# **Official Transcript of Proceedings**

## **NUCLEAR REGULATORY COMMISSION**

Title: Advisory Committee on Reactor Safeguards  
NuScale Subcommittee: Open Session

Date: Tuesday, February 4, 2020

# Steam Generator Design

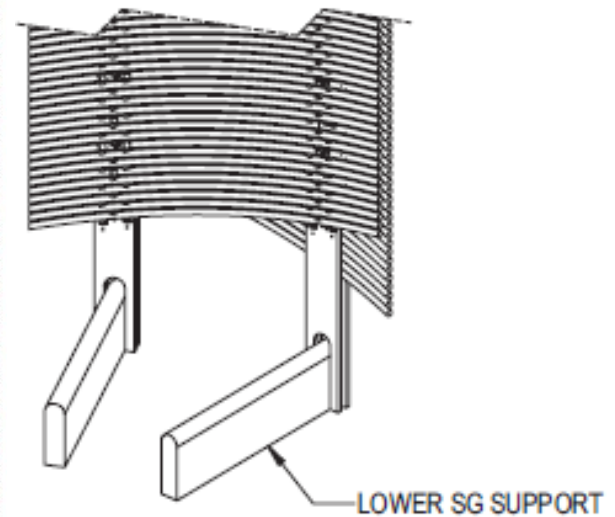
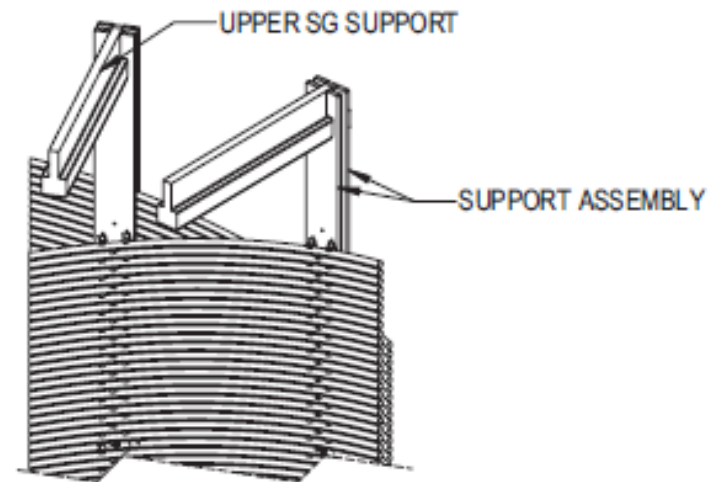
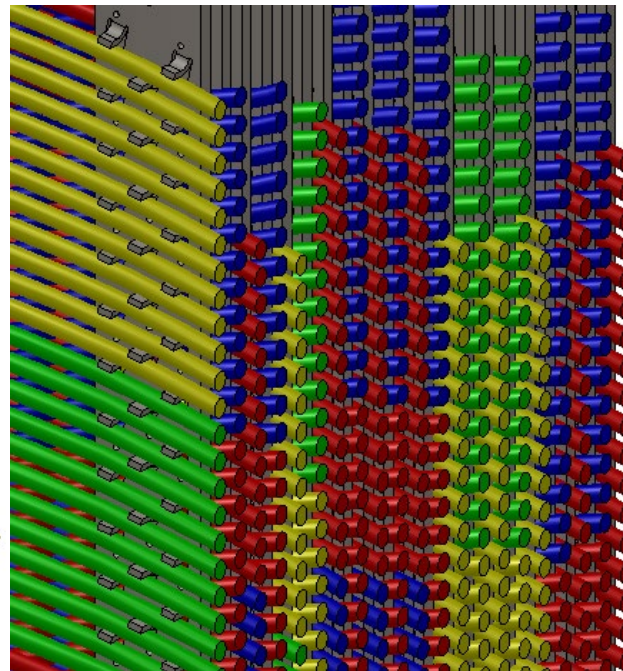
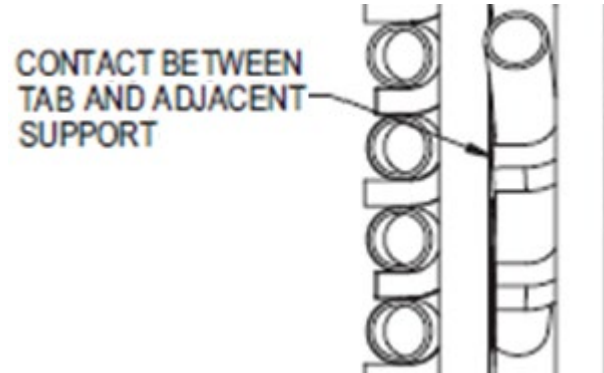
6 MEMBER MARCH-LEUBA: Well, while you have  
7 it there, you think incorporation of operating  
8 experience, almost every coal fired plant in the world  
9 uses a helical steam generator, right.

10 How does this one differ from the existing  
11 ones, I mean, the ones where we have a lot of  
12 experience with, the coal fired plants? Is there  
13 anything special about NuScale steam generator that  
14 makes it different?

24                 MEMBER RICCARDELLA:    Would you give a  
25          little more detail? You said three-point support. I

19 Also here in the middle and at the, on the  
20 right here we show a little bit about our steam  
21 generator support system. Our support system is  
22 accomplished by the steam generator support plates.  
23 On the bottom middle inset here, you'll see the steam  
24 generator tubes and their interaction with the steam  
25 generator support plate.

1           The steam generator support plate has  
2           three tabs of support for each tube. Then there is  
3           common tabs between the tubes. Those tabs are bent  
4           out from the plate material. And they provide a  
5           three-point support method for the tube as it curls  
6           through and contacts the plate.

7           In addition, those plates are sandwiched  
8           together, which you can kind of see in the upper  
9           middle side view of the drawing there, where two  
10          plates and their associated tabs will be sandwiched  
11          together and in contact to prevent the tubes from  
12          moving back and forth or to constrain their growth  
13          related to the axis of the helical coil.
